**FORM P2: SITE PLAN ADMINISTRATIVE – Development Facilitation Team (DFT) as of 12/25/2022****\_ SITE PLAN ADMINISTRATIVE – DFT**

Request Description: \_\_\_ DFT review of EPC approved Site Plan for City Fire Station 12

PROJECT NUMBER: PR-2024-010705  
 Application Number: SI-2024-01086  
 This plan is consistent with the specific Site Development Plan approved  
 by the Environmental Planning Commission (EPC) dated \_\_\_\_\_  
 and the Findings and Conditions in the Official Notification of  
 Decision are satisfied.

**CITY OF ALBUQUERQUE**  
CAPITAL IMPLEMENTATION PROGRAM  
**AFD FIRE STATION 12**  
1474 LINN AVE. N.E.  
ALBUQUERQUE, NM 87123

Sheet **LS-101**

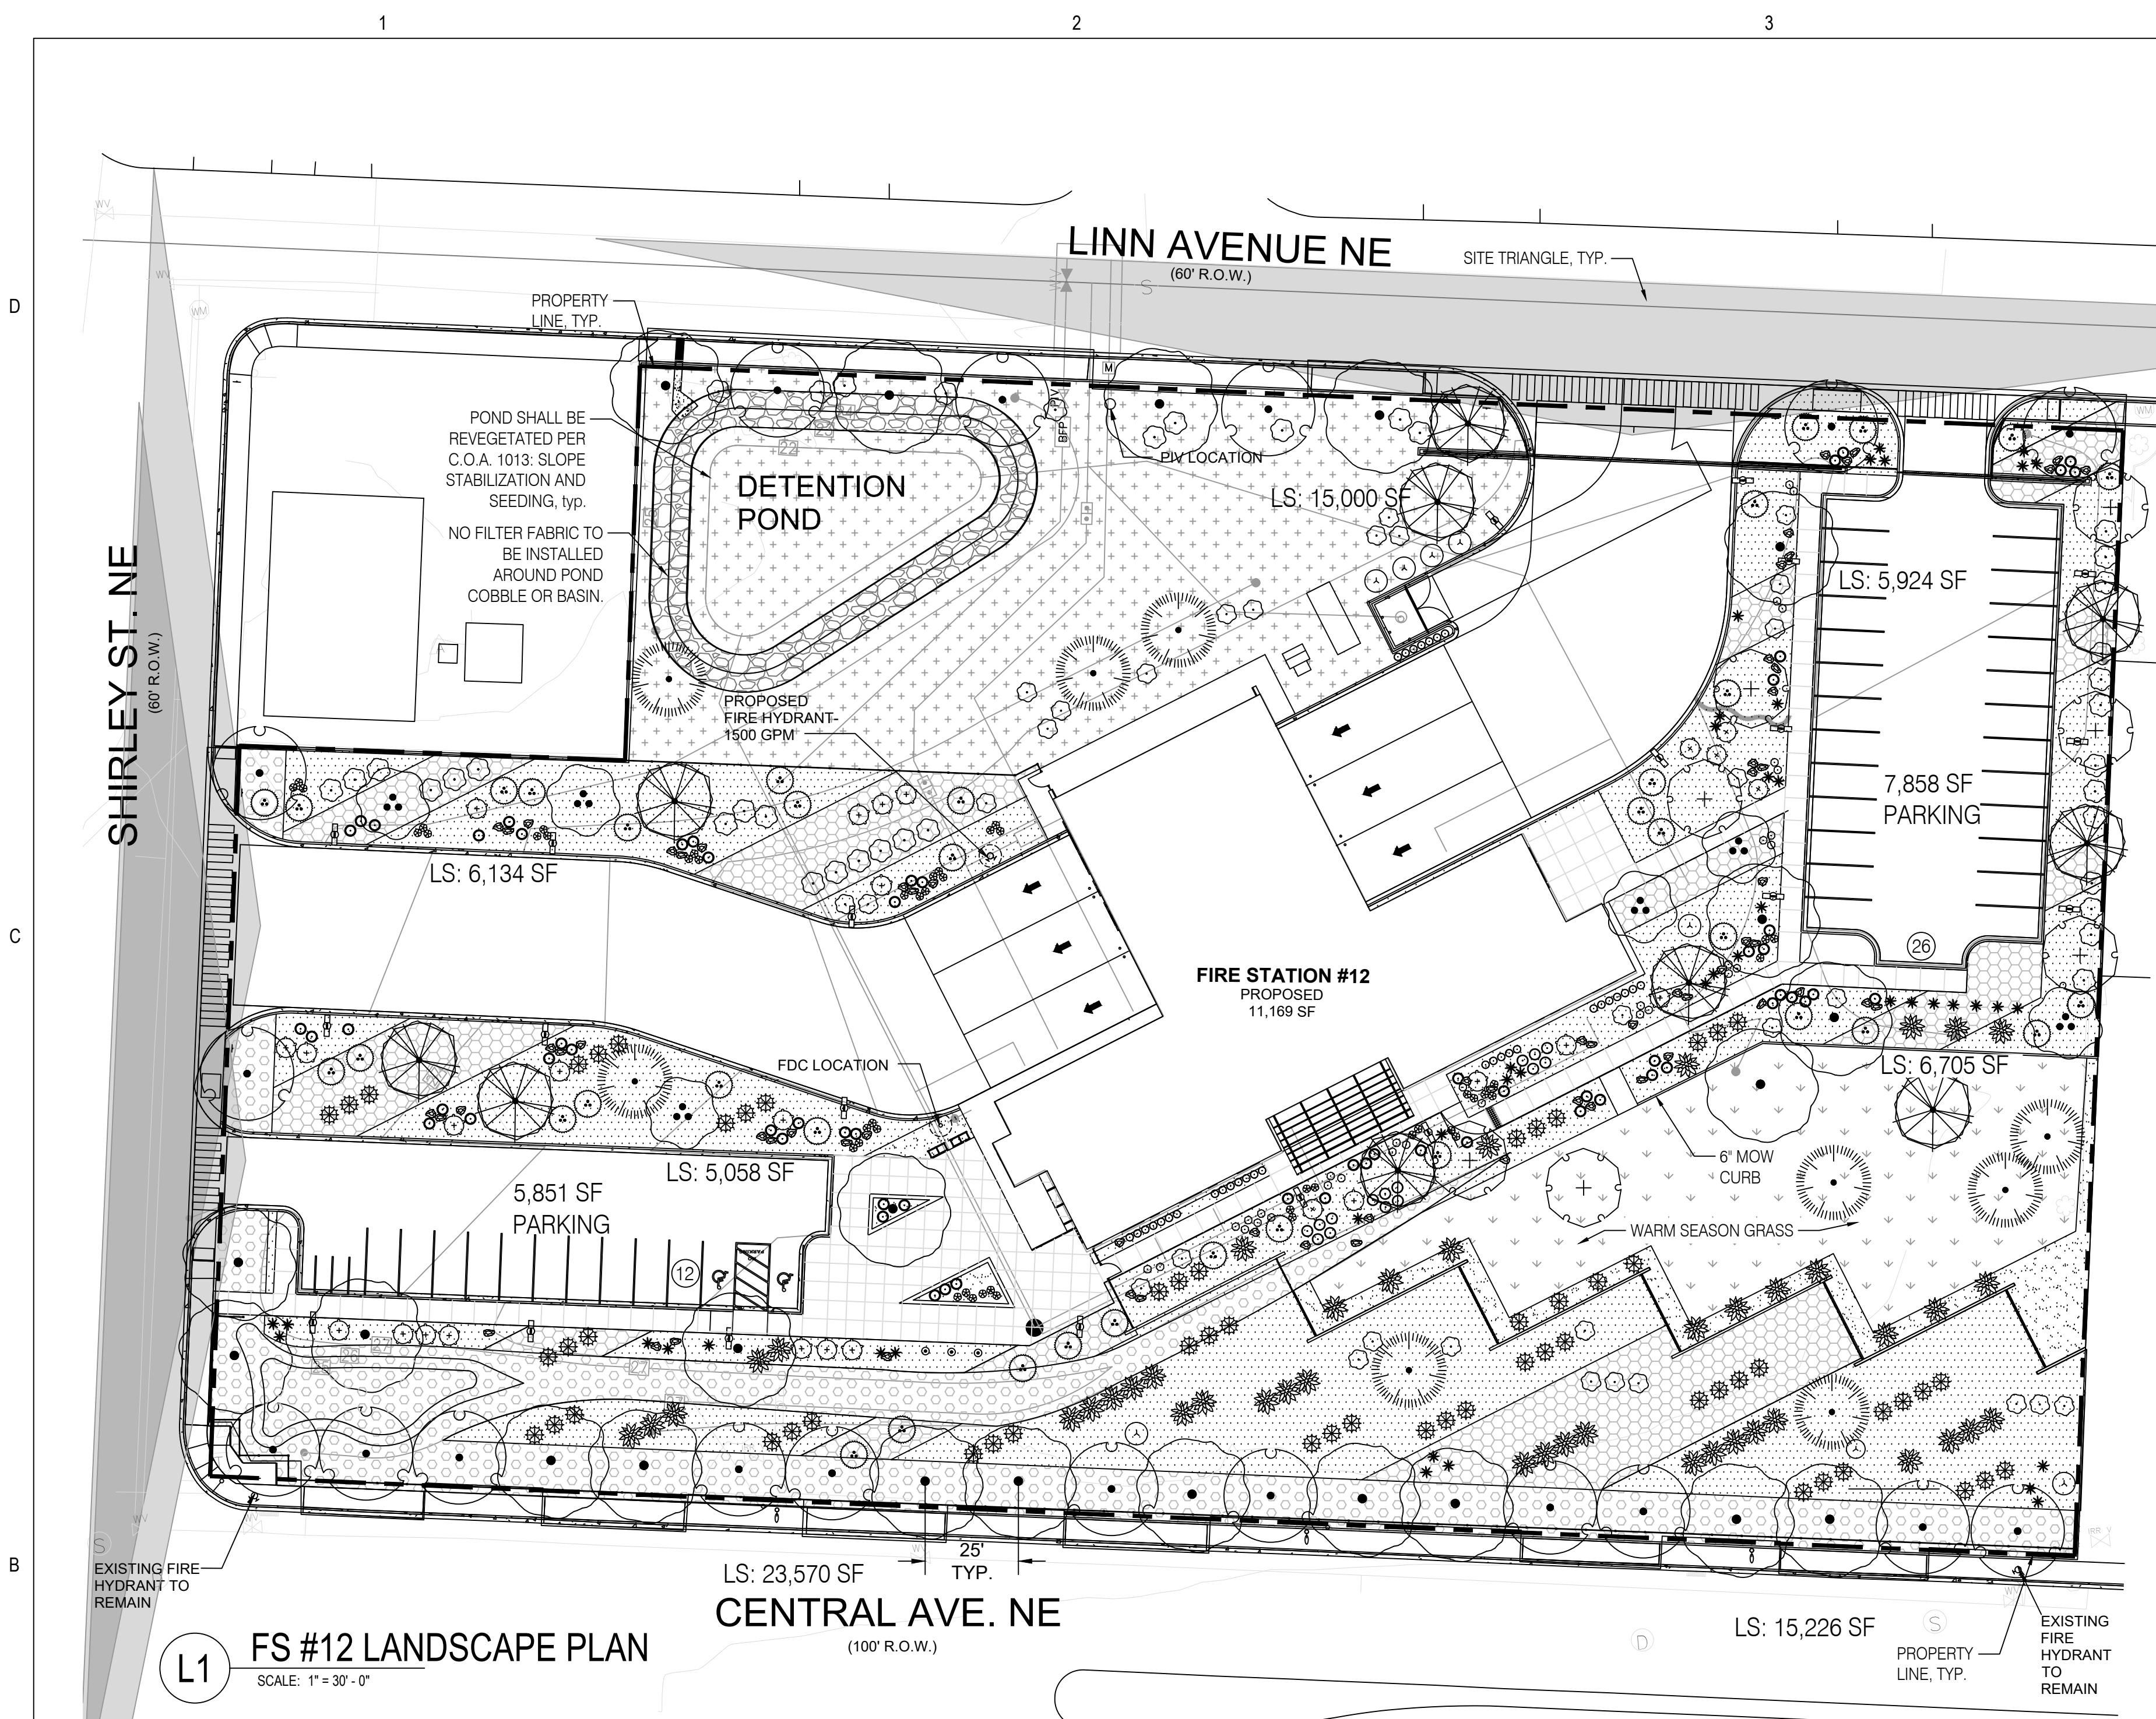
PER 5-6(C)(5)(A), ALL VEGETATED MATERIAL REQUIRED BY THIS SECTION 14-16-5-6 SHALL BE PLANTED IN UNCOMPACTED SOIL. PLEASE ADD A NOTE TO THE LANDSCAPE PLAN GENERAL NOTES TO REFLECT THIS CODE.

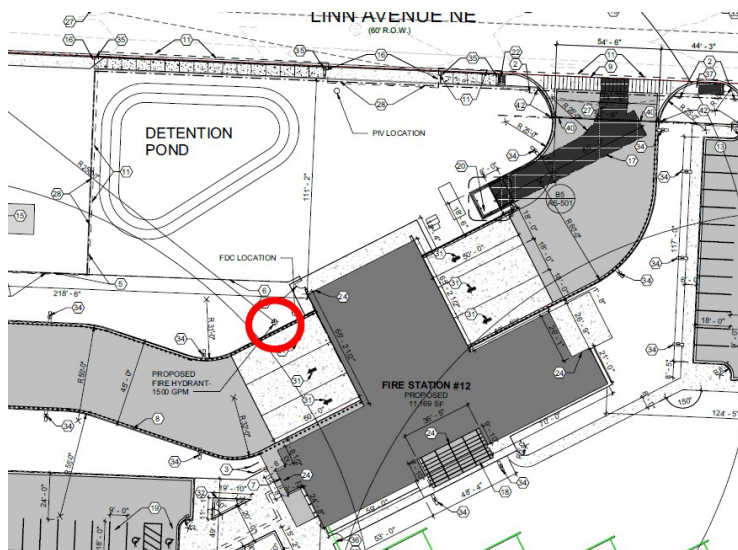
*Per 5-6(C)(7)(a), vegetation required by this Section 14-16-5-6 shall be located at least 3 feet in any direction from any fire hydrants, valve vaults, hose bibs, manholes, hydrants, and fire department connections. Please confirm compliance with this code.*

**Applicant Response:** Shrubs are have been moved and are located more than 3 feet from the fire hydrant.
